Response to Comments
Notice of Construction
DE16NWP-003, Revision 1–
Effluent Management Facility
June 18 – July 20, 2018

*Summary of a public comment period
and responses to comments*

Notice of Construction
DE16NWP-003, Revision 1
Effluent Management Facility
June 18 – July 20, 2018

Comment period: Effluent Management Facility June 18 through July 20, 2018
Order: Non-Radioactive Air Emissions Notice of Construction Approval Order Conditions and Restrictions DE16NWP-003, Revision 1
Permittee(s): United States Department of Energy
Issuance date: December 20, 2019
Effective date: December 20, 2019

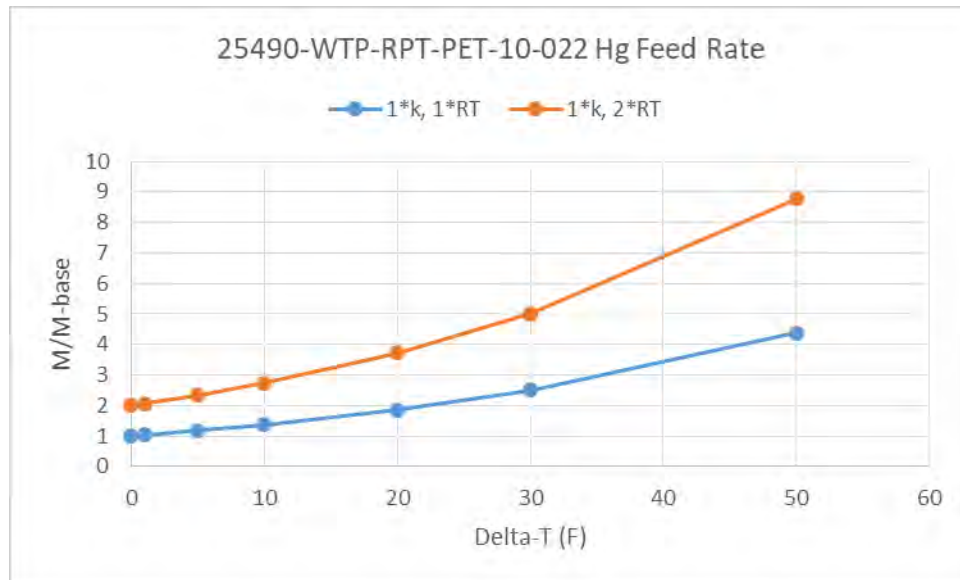
Concern 3: The DMM emission rate in 24590-BOF-M4C-DEP-00001 does not consider the range of temperatures and tank hold-times that can occur during EMF operations. Sections 6.1.22 through 6.1.28 indicate that the estimated DMM formation rate were based on single values of temperature and tank residence time. However, it is the opinion of this reviewer that these values will likely vary during plant operations and that this variation should have been considered in the DMM formation estimates. For example, Attachment 1 of CNN 160522 (SRNL letter “Input for Dimethylmercury Formation and Partitioning) proves a range of operating temperatures for WTP vessels¹. The variation from minimum to maximum operating temperature ranges from approximately 10 °F to 135 °F, depending on the vessel. It is recognized that the vessels in the EMF will likely not experience temperature fluctuations at the upper end of the quoted range. However, variations should have been estimated and accounted for in the DMM formation estimate. Alternatively a maximum temperature for each vessel should have been used.

However, process upsets or temporary shutdowns are likely during LAW operations and this will result in longer hold times and subsequently higher DMM formation rates.

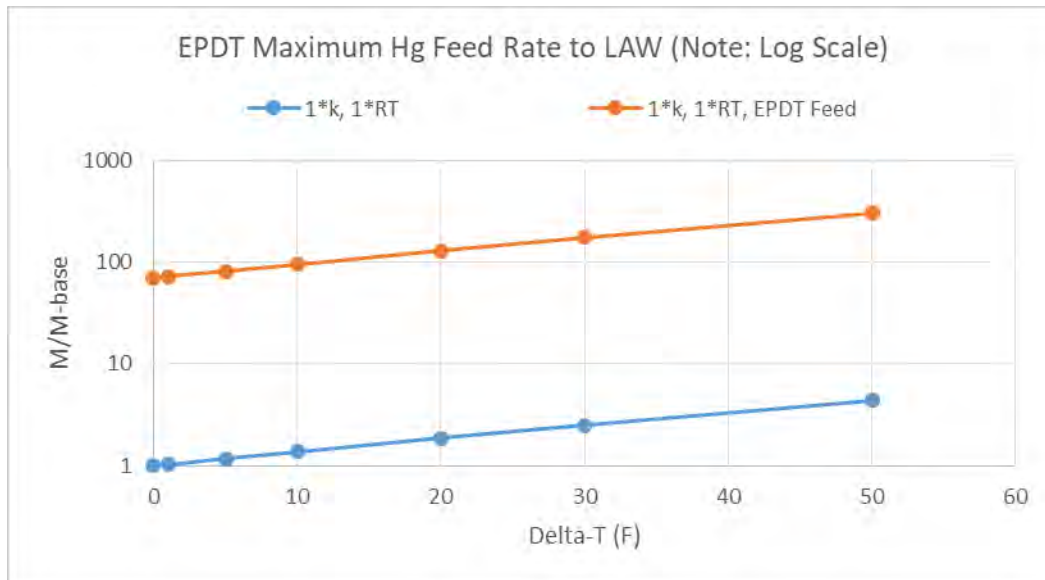
The impacts of temperature and reaction time on DMM emissions from the EMF are illustrated in the following figure:

Values in this figure were created by this reviewer using the calculation approach outlined in 24590-BOF-M4C-DEP-00001. The parameter (M/M-base) represents the estimated DMM emission rate from the EMF for each condition divided by the emission rate calculated using the values for temperature and RT in the report. Delta-T represents the assumed temperature increase ($^{\circ}\text{F}$) from the values reported in Sections 6.1.22 through 6.1.27 of 24590-BOF-M4C-DEP-00001. Note that some input parameters for these calculations were not readily evident in 24590-BOF-M4C-DEP-00001 and this reviewer was not able to exactly match the Permittees base emissions rate of $5.29\text{E-}07$ g/s. Rather the base rate calculated was $1.5\text{E-}07$ g/s.

Finally, the mercury feed rate to the LAW system will also have an impact on DMM emission rates from the EMF. The following graph represents the predicted DMM emissions using the mercury feed rate reported in Appendix M of 25490-WPT-RPT-PET-10-022 ($2.79\text{E-}03$ kg/hr feed to LAW melter, process stream LFP04a) and the highest estimated mercury feed rate reported in the recent Environmental Performance Demonstration Test (EPDT) for the LAW system ($1.93\text{E-}01$ kg/hr, feed to LAW melter, process stream LFP04a). Values were computed using the same approach outlined in 24590-BOF-M4C-DEP-00001. In this figure, the blue line represents results using the feed rate from 25490-WPT-RPT-PET-10-022 and the orange line represents the results using the EPDT feed rate. Note that the y-axis is a logarithmic scale.

Figure 1: 2004 Meteorological data Windrose (direction represented as “blowing from”) and corresponding annual air concentration for a 1 g/s vapor release from the EMF. Data and model were taken directly from 24590-RMCD-04990.

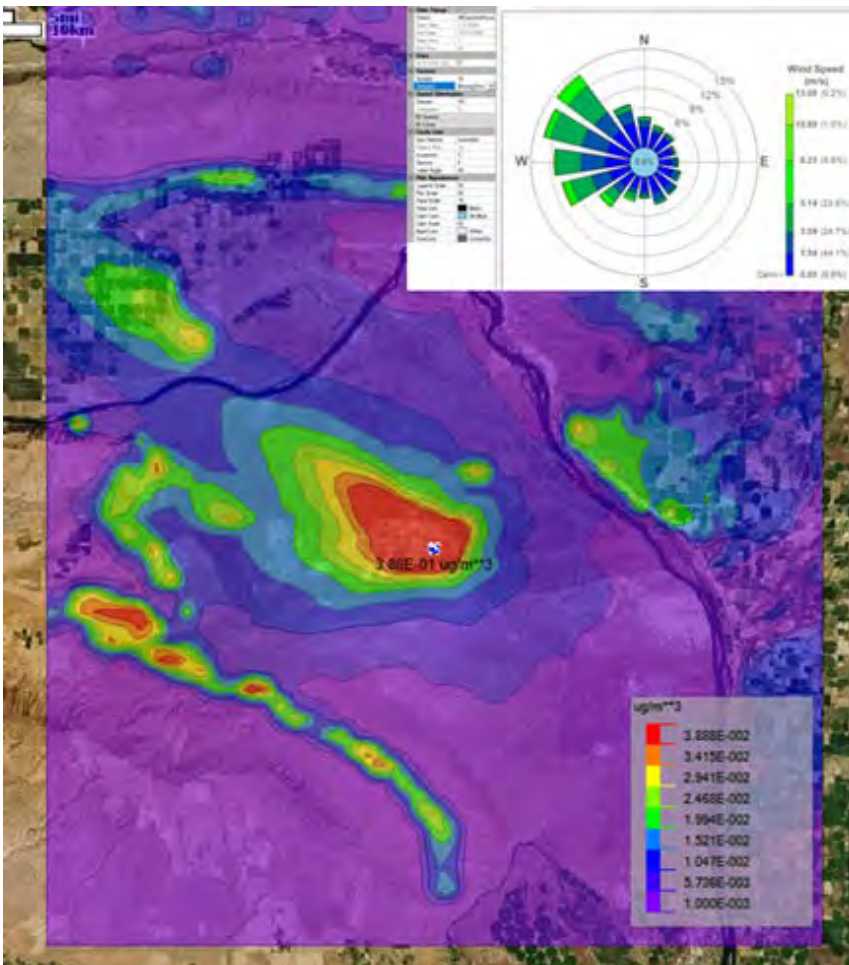
As you are aware, the wind at Hanford generally blows from the NW to the SE and so that a vapor plume released from the EMF should also flow in a SE direction. This is not the case for the model files provided to me in 24590-RMCD-04990. The following figure provides a Windrose Plot (data represented as "blowing from") for the 2004 surface meteorological data along with the corresponding predicted annual air concentration for a 1 g/s vapor release from the EMF. Both the meteorological data and AERMOD model inputs used to generate this figure were taken directly from 24590-RMCD-04990.

Obviously, the vapor plume in Figure 1 appears to be moving in the opposite direction as the wind. A subsequent review of the AERMOD input files contained in 24590-RMCD-04990 revealed that each contained the command “ME WDROTATE 180” which shifts the wind direction by 180 degrees.

To clarify the permitted TAPs, Table 1 was added to the approval order listing the pollutants, estimated emission rates, and their ambient source impact. Approval Condition 1.1.2 will be changed to state, "All TAPs, as listed in Table 1 of this Approval Order, shall be below their respective ASIL or approved through a Second Tier review."

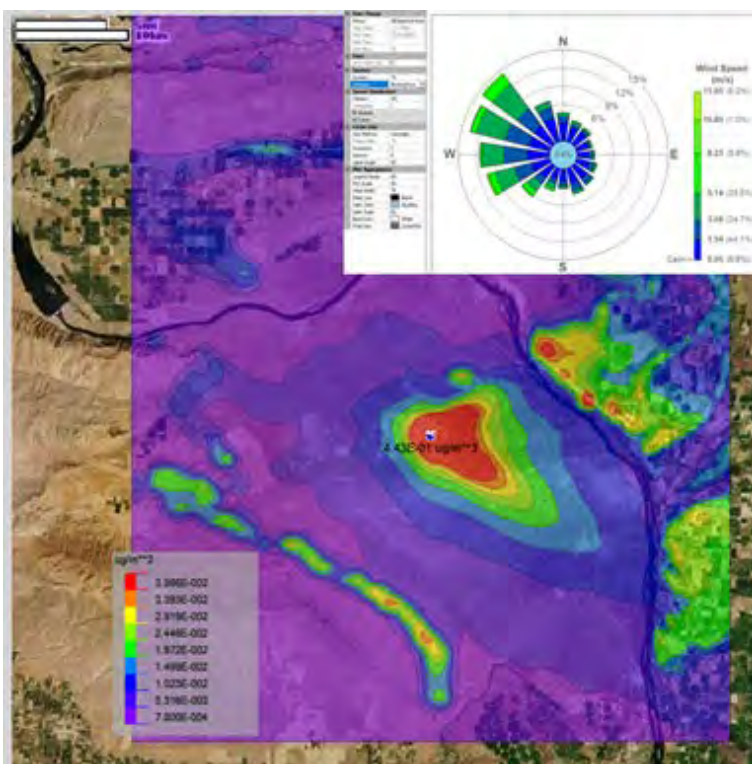
Removal of the “ME WDROTATE 180” command results a vapor plume moving with the wind (Figure 2).

The impacts of shifting the wind direction on the maximum vapor concentration is provided in the Table 1. The first three rows in Table 1 correspond to the 1-hr, 24-hr, and annual values reported on Page 21 of 24590-WTP-EMV-15-007, Rev 0. These values were also reproduced in this analysis using the AERMOD and 2004 meteorological files from 24590-RMCD-04996. The next three rows represent the 1-hr, 24-hr, and annual maximum values generated by removing the 180 degree shift of the wind direction and applying Permittee’s method of taking each from calendar year 2004. The final three rows show the maximums for each parameter using the corrected wind data and evaluating all five years of meteorological data. The last column in the table presents the difference between a new maximum value and that reported by the permittee. Altering the wind direction results in higher concentrations for all parameters under all conditions presented in the Table. The increase in maximum values ranges from 46% to 80%.
